Product Change Notification

113623 - 00

Change Notification #: 113623 - 00
Change Title: Intel® Server Chassis P4304XXSFCN
PCN 113623-00, Product Design, Label
Update Hard Disk Drive Tray to add 2
latches and labels, Update Regulatory
Labels, and Update the Front Panel Printed
Circuit Board and Power Button LED
Date of Publication: February 4, 2015

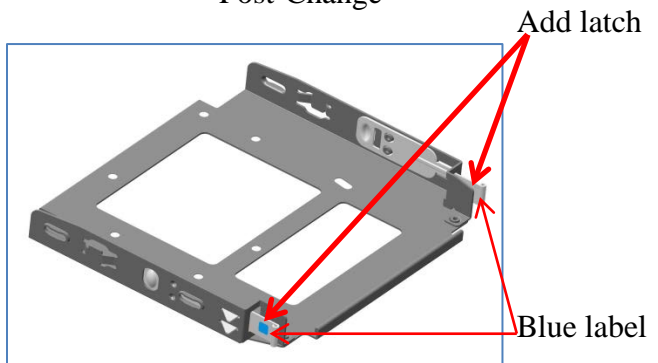
1. Add two latches and labels for the fixed HDD (Hard Disk Drive) tray to enhance the robustness of the HDD tray and indicate the touch point for the HDD tray assembly.

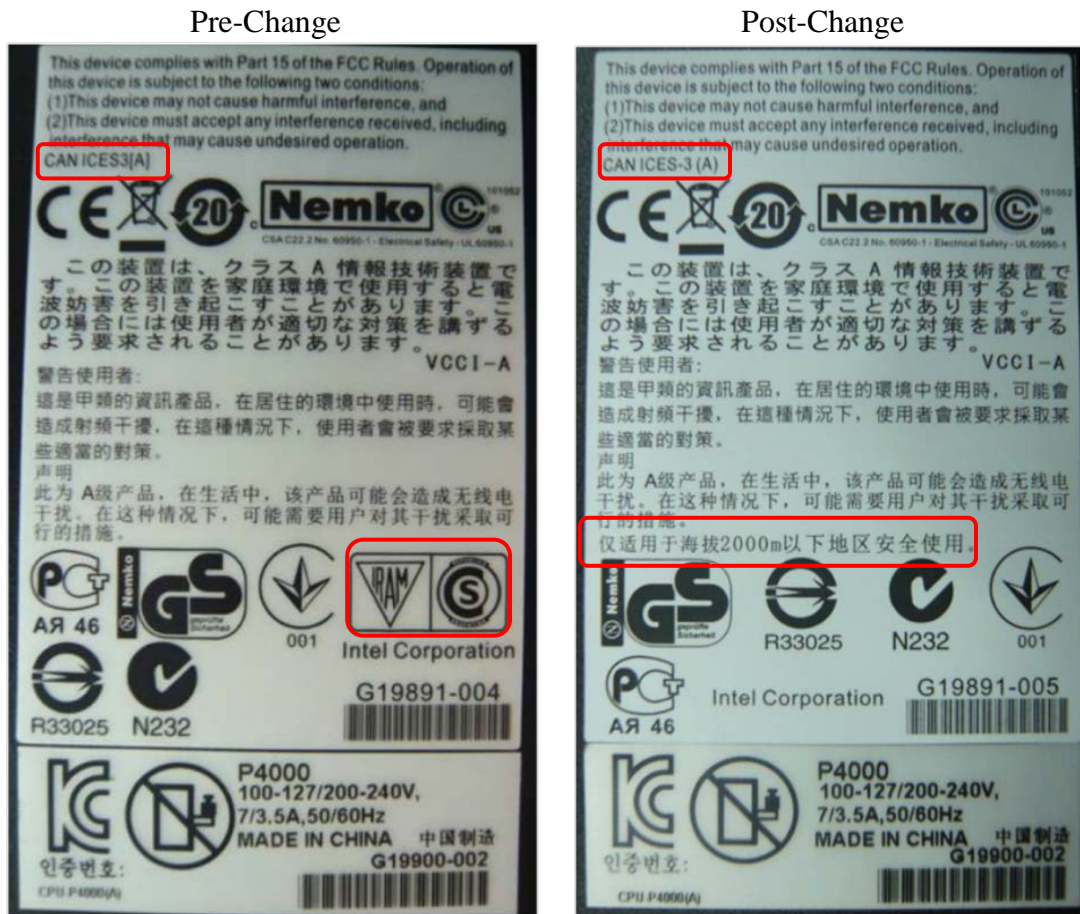
- Add two resistors on the Front Panel Printed Circuit Board to improve the LED brightness. Customers will not see any functional difference.
- Update the power button cap icon outer diameter from 4.0mm to 3.5mm. The transparent area on the post-change button is more centralized than on the pre-change one. The purpose of this change is to make the button brighter. The post change button icon is smaller, but more of the icon area is directly illuminated by the LED. See the picture below for details.
